In order that we may complete our review of Westinghouse Electric Corporation topical report WCAP-7832 (Non-proprietary) entitled "Evaluation of Steam Generator Tube, Tube Sheet and Divider Plate Under Combined LOCA Plus SSE Conditions," additional information is required. Enclosure 1 identifies the required information.

EVALUATION OF STEAM GENERATOR TUBE, TUBE SHEET AND DIVIDER PLATE
UNDER COMBINED LOCA PLUS SEE CONDITIONS

This WCAP presents an analysis of the Steam Generator structural integrity, as designed, to demonstrate its capability to withstand the combined stresses of a LOCA and a SSE. Detailed discussion of various off-design situations and other accidents are not considered germane to that purpose. However, for additional clarification, responses to questions 2Ac, 2Ad, 2Ba, 2Bb, and 2Bc have been provided.

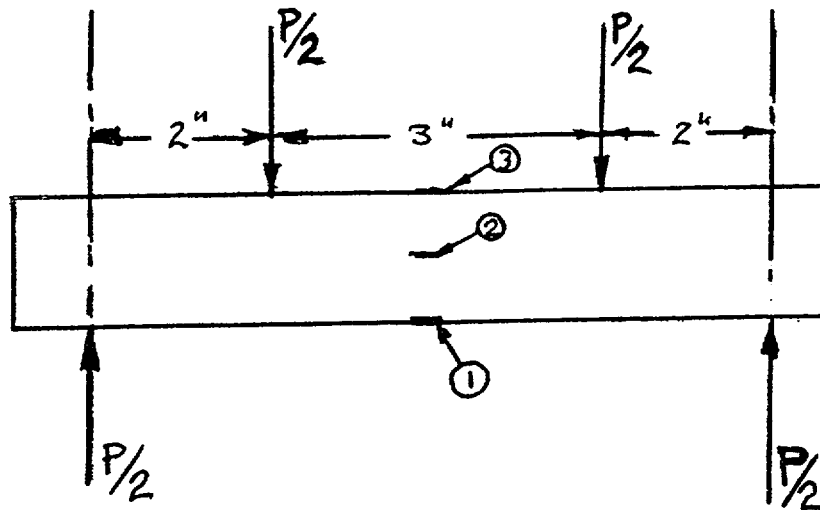
AEC Question 2.A.c.: Provide a reference or additional data on crack propagation tests on tubes loaded by combined internal pressure and axial bending moments.

Reply 2.A.c: External bending loads have an influence on the burst pressure of flawed tubes. This effect has been observed at bending stress levels up to 34,000 psi and is considered insignificant in that range (0-34,000 psi). Tube movements, induced for example by a seismic event, can generate bending stress which may facilitate plastic bulging of the crack area. However, while bending stresses lower the pressure at which point stresses exceed the yield strength, it is not certain that such stresses greatly affect the fully plastic limit pressure of flawed tubes.

Examination and testing of tube specimens removed from operating steam generators which have surface stress-corrosion cracks have indicated that the ductibility of the uncracked tube material has not degraded. Several tests were conducted with bending stresses superimposed on internally pressurized tubes to determine if this load would accelerate crack propagation. It is concluded from those tests that there is no strong effect of bending stress on crack propagation. Further discussion, data, and SEM photographs are included in the response to question 2Bd, and the test data of Table III-3.

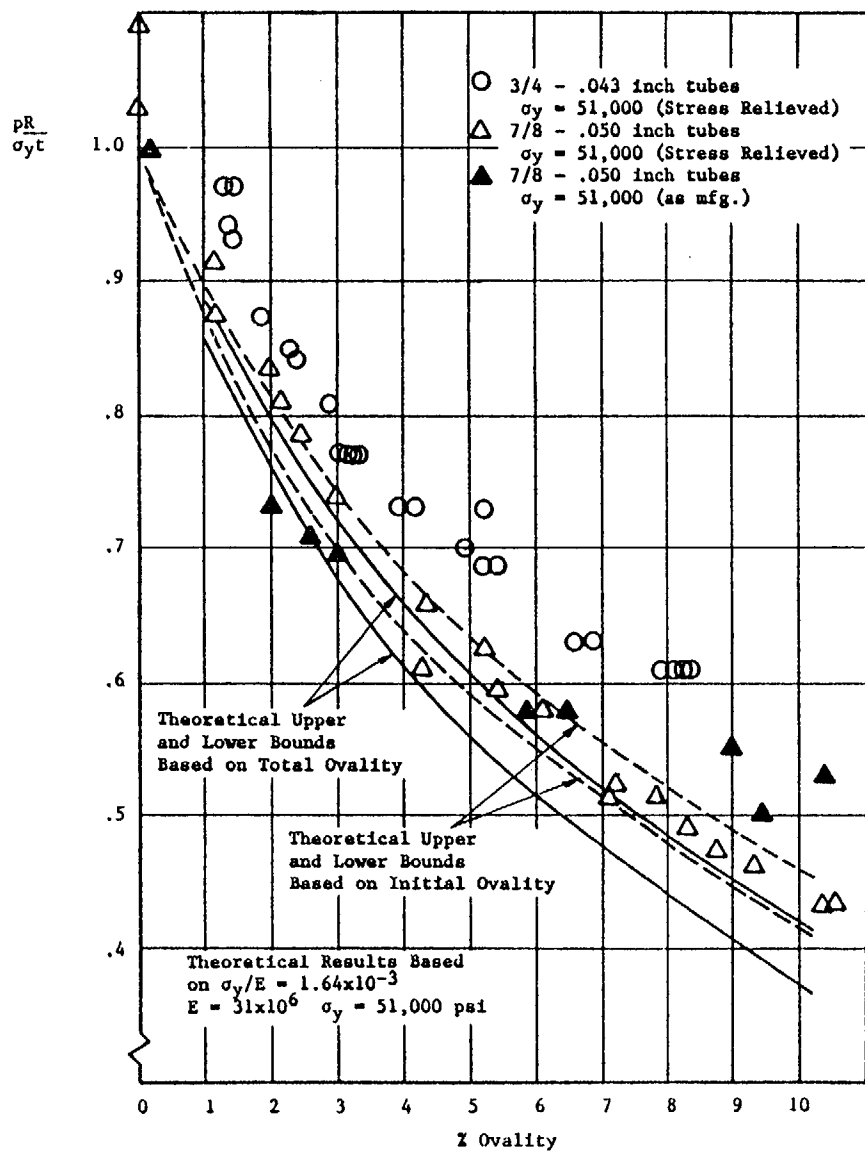
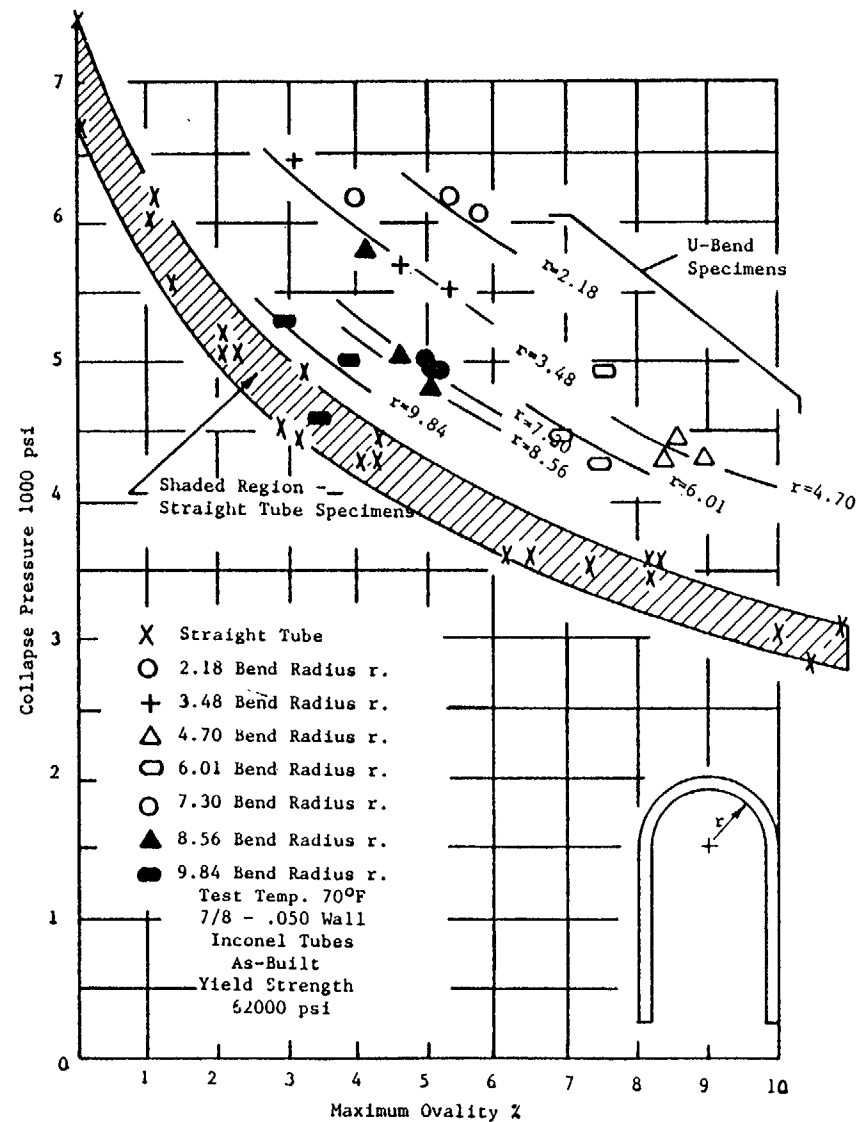
AEC Question 2.A.d.: Provide a reference or additional data on the tube collapse tests, and the analytical correlation and analysis on which the extrapolation of test results to tubes of different yield strength and wall thickness is based.

Reply 2.A.d.: Collapse tests have been conducted at the University of South Florida, Tampa, Florida, under the auspices of W Tampa Division on slightly oval (0-10%) straight and U-bend Inconel tubular specimens of various sizes. Some of the significant test results are summarized below:

The results shown above are for straight tubular specimens. Test results indicate that collapse pressures of U-bends are higher than for straight sections as shown in attached Figure 6 of reference 1. Pressure versus ovality for straight tubes and for U-bend tubes (Inconel 600) illustrate the effect of ovality on the normalized, dimensionless collapse pressure term $\frac{pp}{\sigma_y t}$ in Figure 5 of ref. 1. where: p is the pressure difference across the tube wall, ρ is the mean tube radius, σ_y is the yield stress, and t is the tube wall thickness.

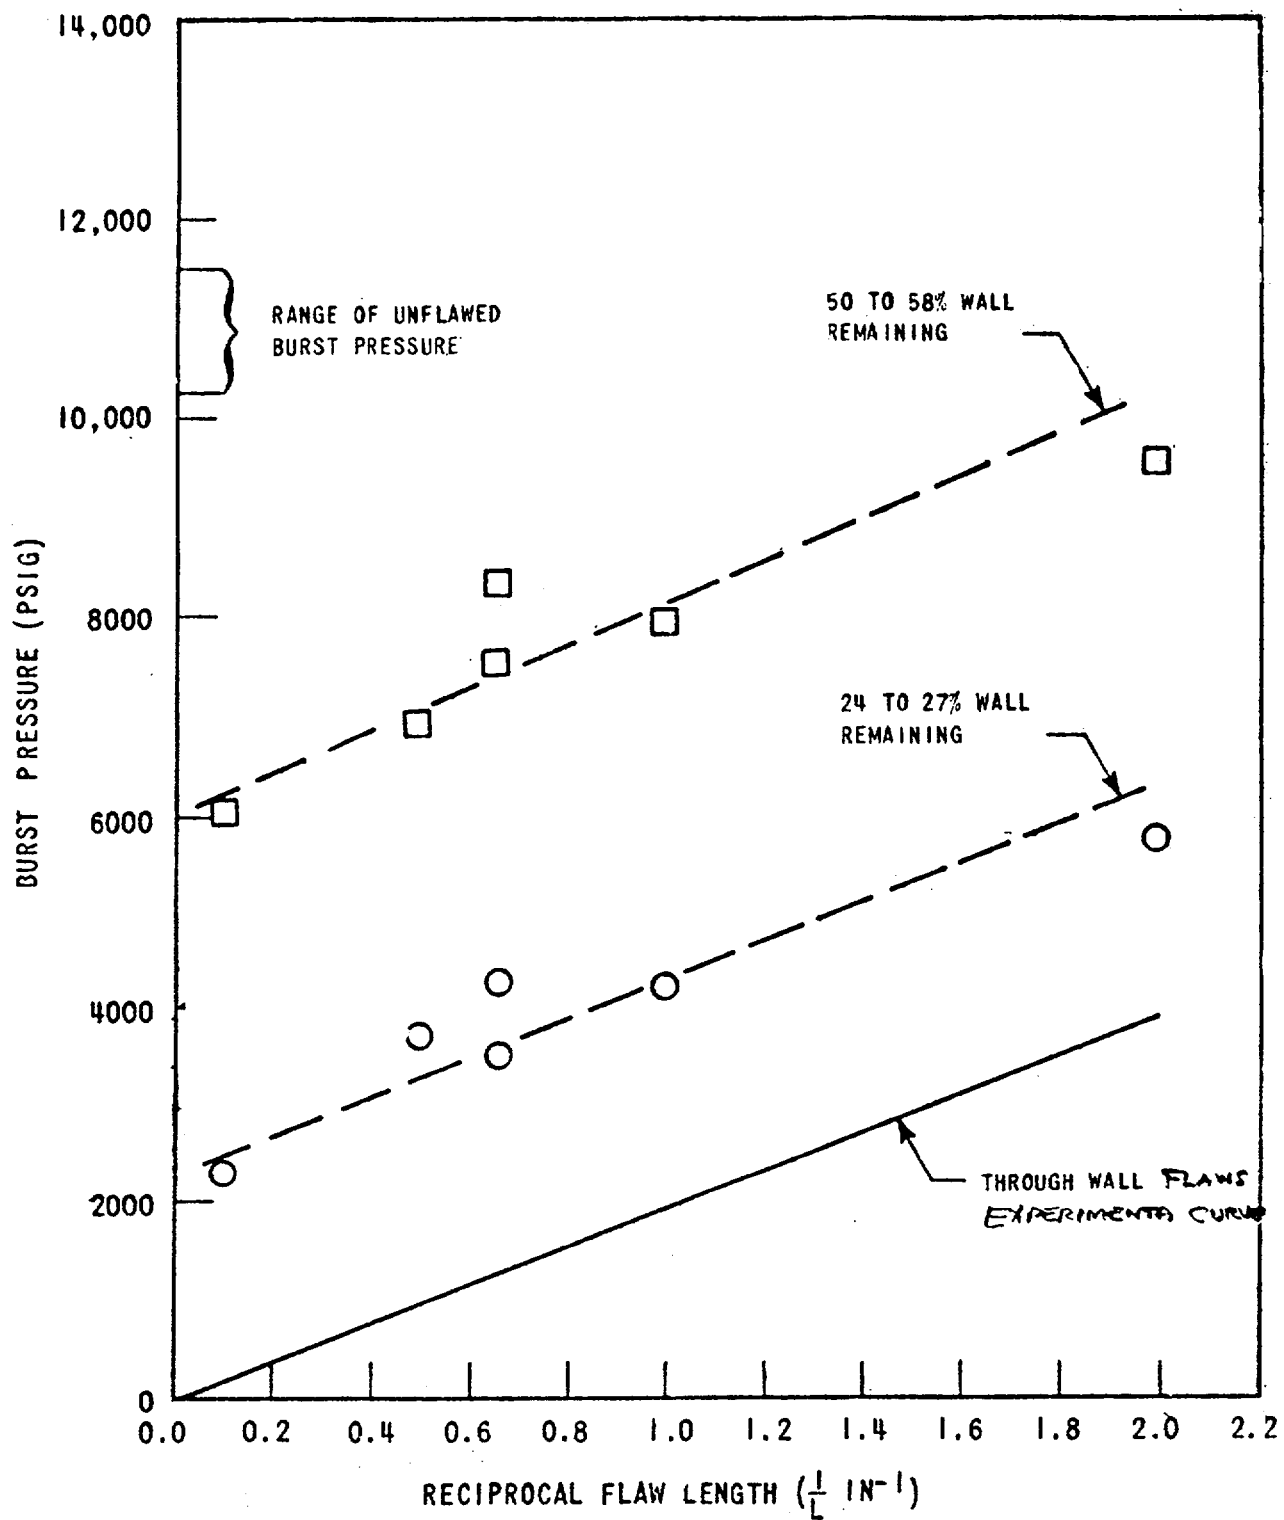
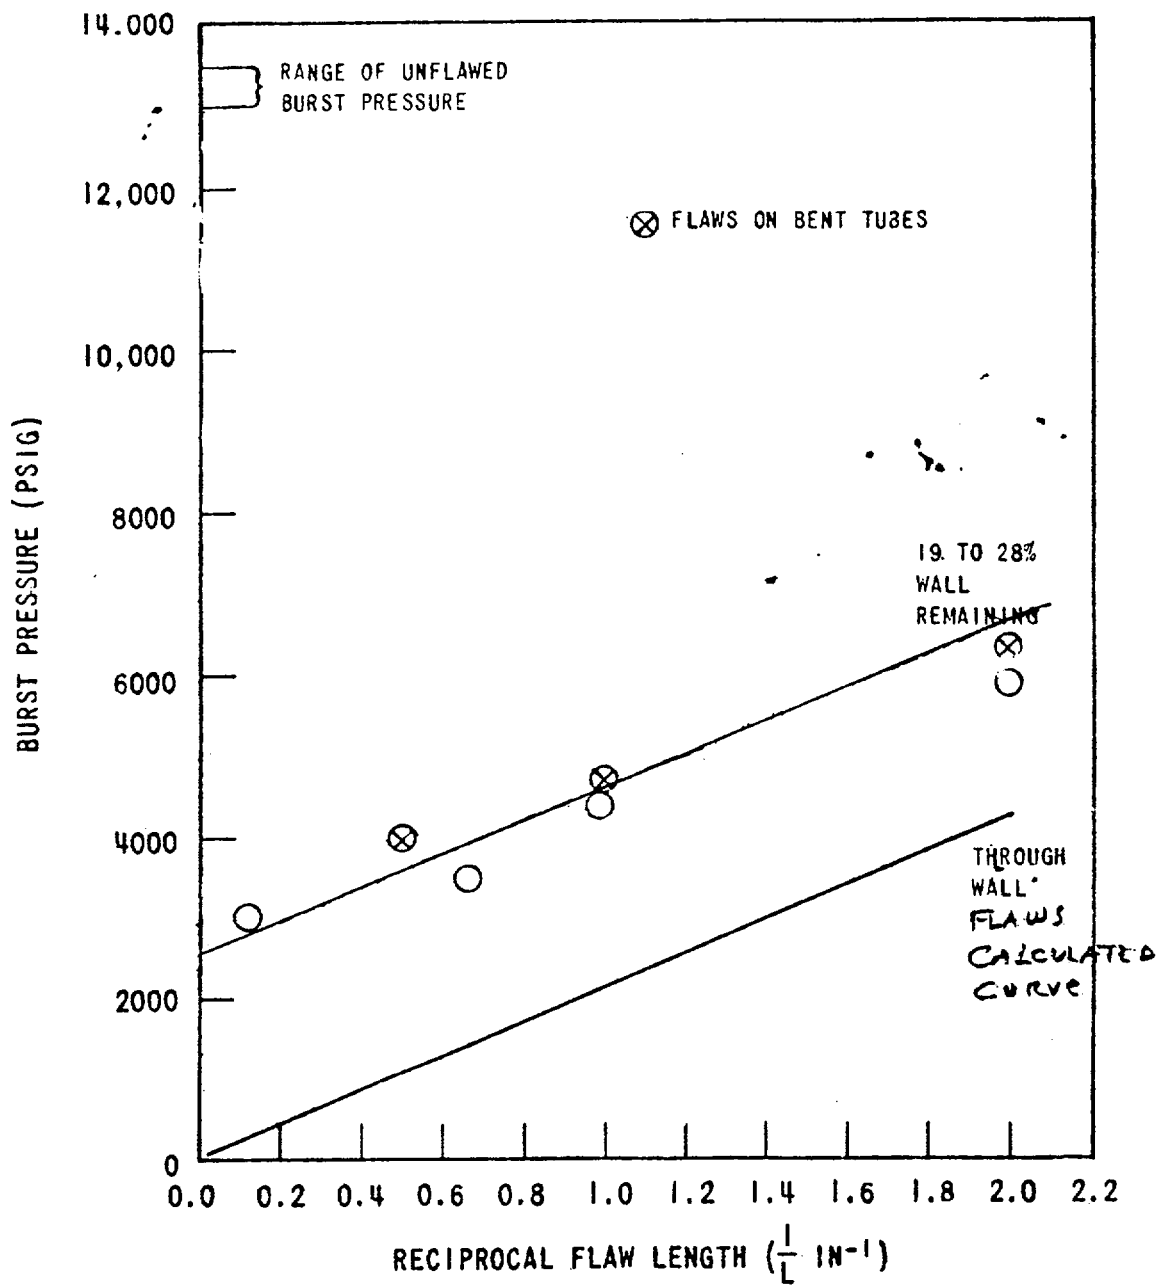
AEC Question 2.B.c: Discuss the effects of local thinning due to wear and local crud accumulation at the tube supports on the burst strength of the tubes.

Reply 2.B.c.: A test program of tubes with simulated wear or local thinning has been run on both 7/8 in. OD and 3/4 in. OD Inconel tubing. The tubes had flats milled on the outer surface of varying axial lengths. The results, presented in Figures 4-1 and 4-2, illustrate the influence of the axial length of the thinned area on burst pressure. It can be seen that for a part wall (24-27% remaining Figure 4.1 and 19-28% on Figure 4-2 for 3/4" tubes) infinitely long defect, the burst pressure is approximately 2500 psi which is greater than plant operating pressure (with zero on the steam side). For smaller length defects, the burst pressure is substantially higher. E.g., for a 1" long, part wall defect, the burst pressure is approximately 4200 psig, and for a 1/2" long defect, the pressure is roughly 6200 psig.
